PCN No#: 042723-2

PCN Title: Add New Qualified Source

## PRODUCT CHANGE NOTICE

Table A - Appearance comparison

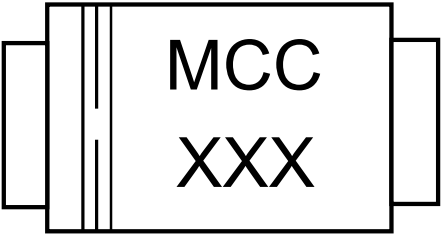
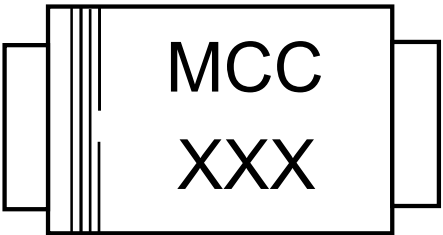
Notification Date	Predict Implementation Date	Change Type	Classification	PCN No
April 27, 2023	July 27, 2023	Add New Qualified Source	Major	042723-2
<b>TITLE</b>				
Add New Qualified Source				
<b>DESCRIPTION OF CHANGE</b>				
<p>This PCN is being issued to notify customers that in order to improve automation and product quality .MCC add new qualified source . Full electrical characterization and high reliability testing has been completed to ensure there is no change to device functionality or electrical specifications in the datasheet.</p>				
<b>IMPACT</b>				
<p>No change in datasheet electrical parameters and product performance.            Table A: Appearance comparison            Table B: Internal Structure comparison            Table C: The list of Products affected</p>				
<b>PRODUCTS AFFECTED</b>				
See Table C.				
<b>WEB LINKS</b>				
<b>Terms And Conditions:</b>	<a href="https://www.mccsemi.com/Home/TermsAndConditions">https://www.mccsemi.com/Home/TermsAndConditions</a>
